RE: CERTIFICATION FOR ST. JOSEPH'S HOSPITAL COMPLEX  
SLOPE EROSION CONTROL PORTION  
(K-15/D6) ENGINEER'S STAMP DATED MARCH 8, 1989

PROJECT TITLE: St. Joseph's Hospital Complex ZONE ATLAS/DRNG. FILE #: J-K-15-Z

1. The Drainage/Grading Plan and Drainage Report can be approved for Preliminary Plat when the following inconsistency is resolved:
  - a. On the previously approved Conceptual Drainage Plan the storm drain size in Marquette street to Roma Ave. is shown as a 24" diameter. The design calculations on the "Existing Conditions" drawing also show it as 24" RCP. Your new submittal show the existing storm drain size as 12" diameter and 15" diameter. Field verify the existing storm drain size, and if it is not 24" dia. as assumed by our previous approval, then additional storm drain improvements, will be required unless new design calculations can show that the existing storm drain has adequate capacity.

RE: CONCEPTUAL DRAINAGE MASTERPLAN FOR ST. JOSEPH HOSPITAL  
COMPLEX RECEIVED NOVEMBER 27, 1985 (K-15/D6)

**DRAINAGE PLAN  
ASBUILT  
FOR  
TRACT 1  
ST. JOSEPH HOSPITAL COMPLEX  
ALBUQUERQUE, NEW MEXICO  
OCTOBER, 1988**

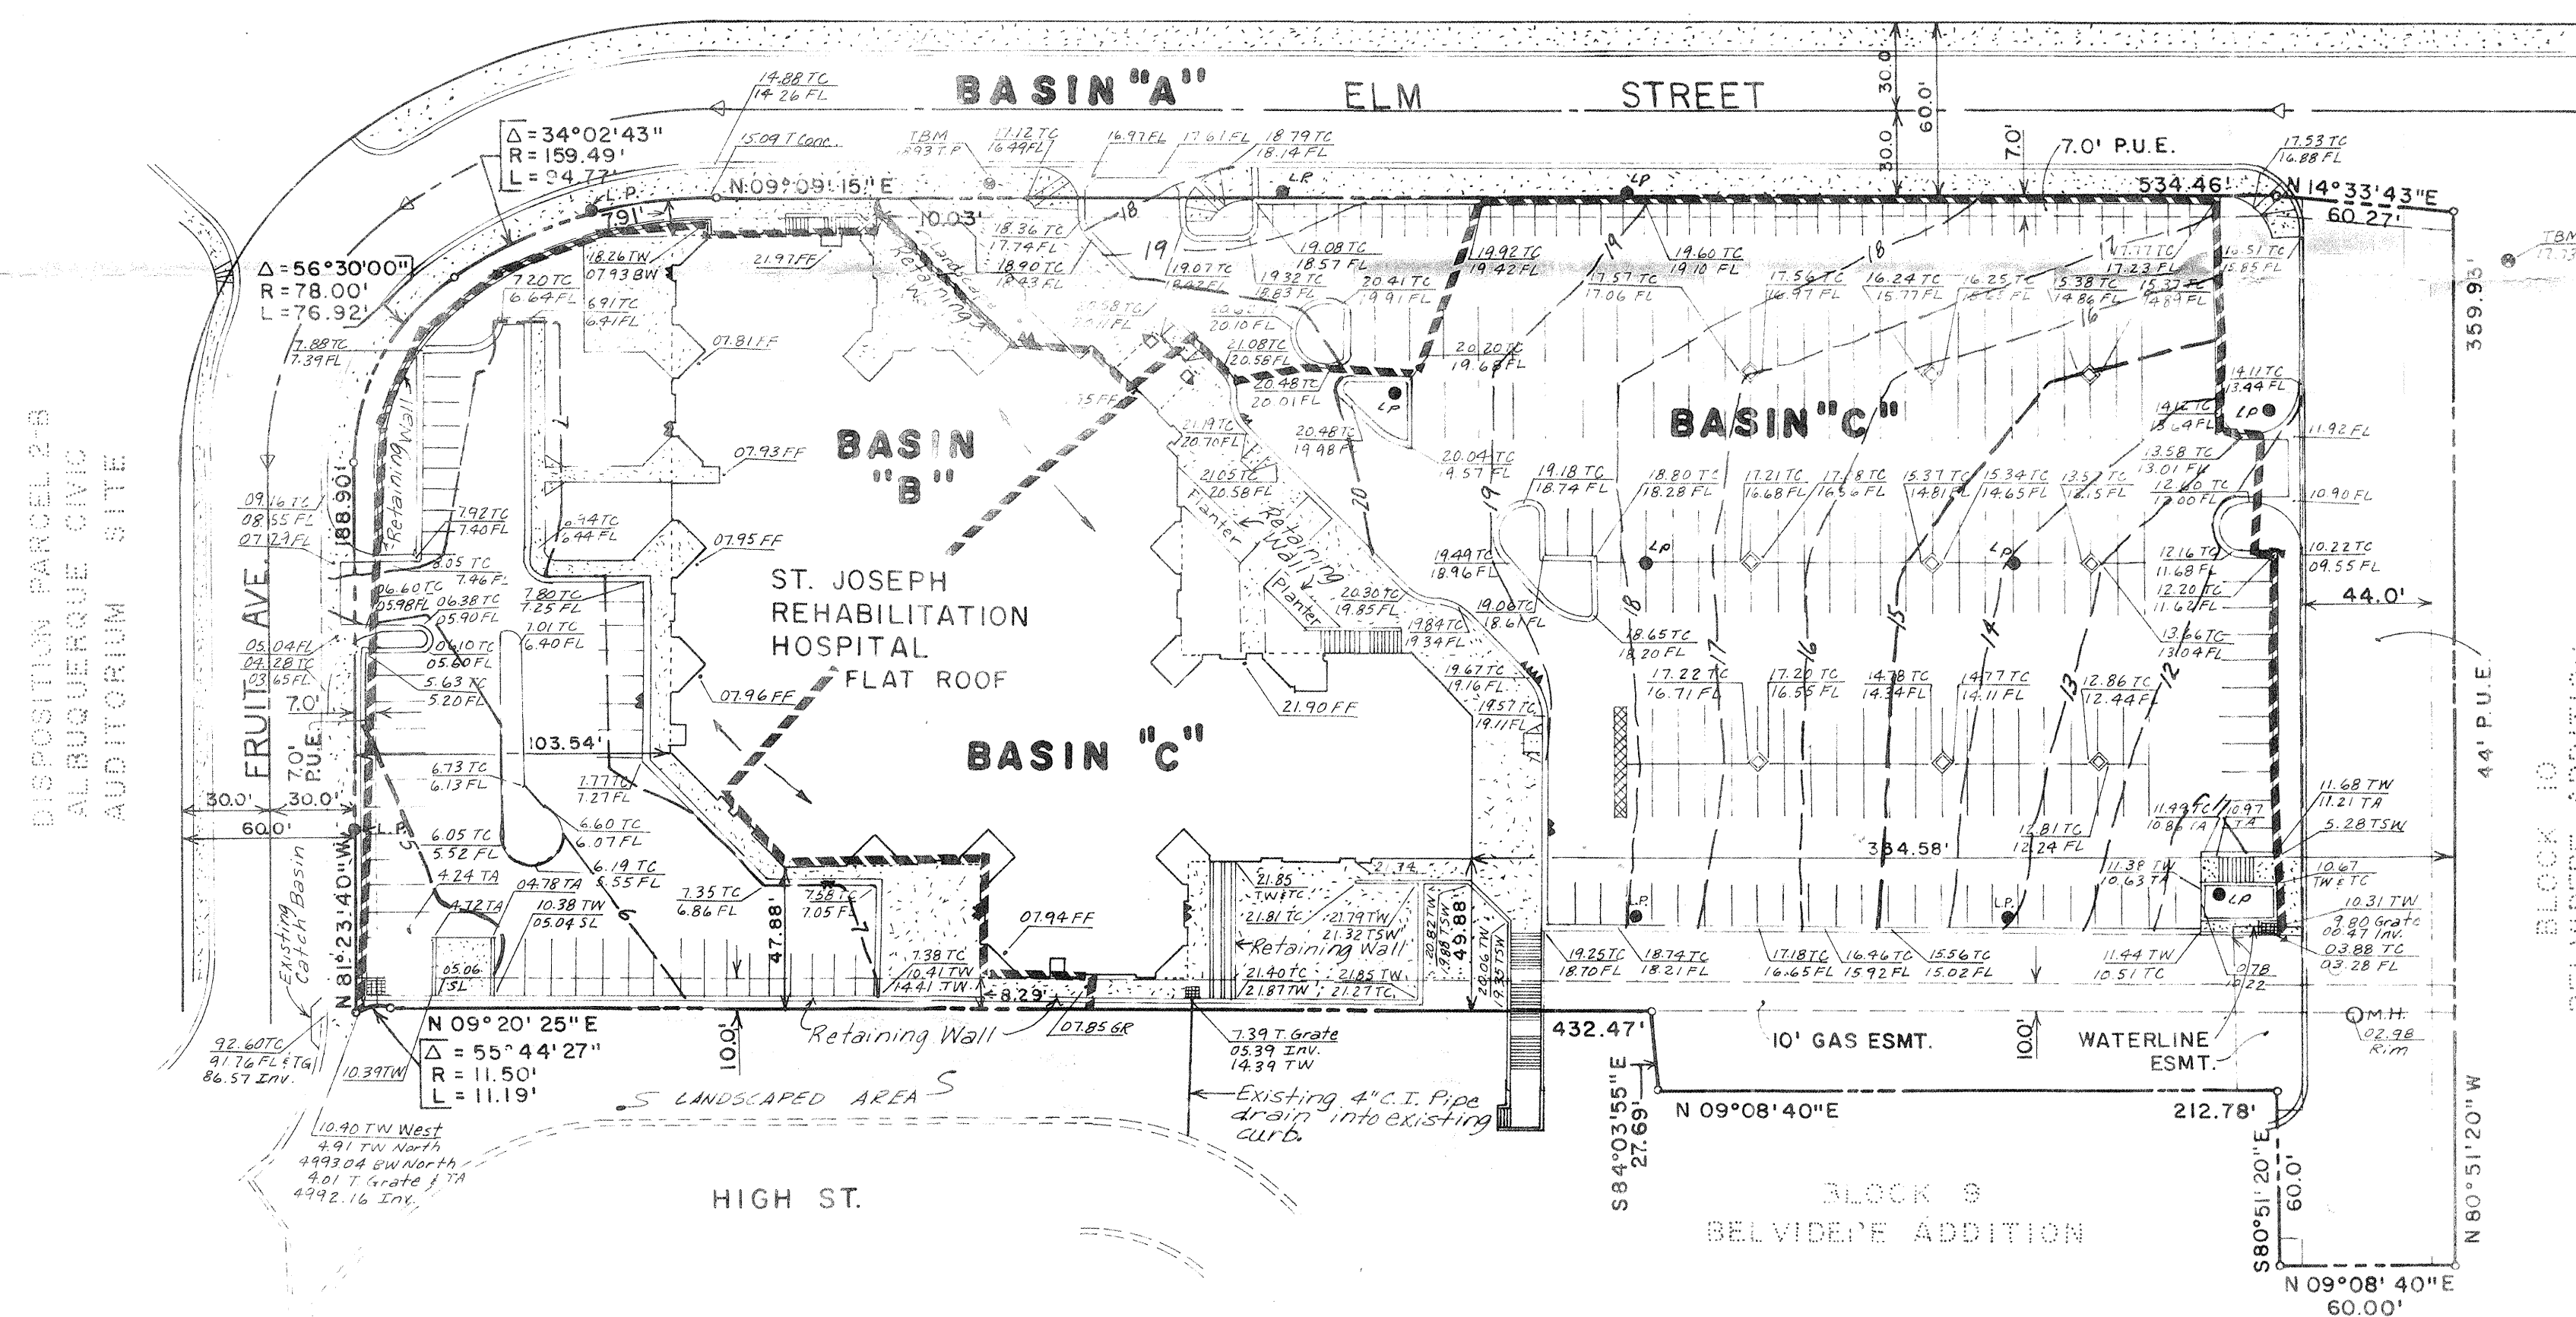
- ✓ 1. Copy of letter of acceptance for Work Order No. 3156.
- ✓ 2. Concurrence from the City Inspection Department for the work done under S.O. #19 process.
3. You must indicate on your plan all as-built structures that correspond to the site project. You indicate a 2' x 2' grated catch basin on the west side, but you do not indicate the 4" C.I. pipe. Please address.
4. Note indicating that Certification is only for the portion shown on the Certification plan and no other areas shown on the original approved drainage plan done by Bohannon-Huston, Inc.

Please be advised that besides the above listed concerns, the problem of erosion on the west slope of the new Rehabilitation Hospital must be corrected and certified prior to issuing a permanent Certificate of Occupancy. Once the above four concerns are satisfied, a Temporary Certificate of Occupancy will be issued until Certification is received for work done for the erosion control.
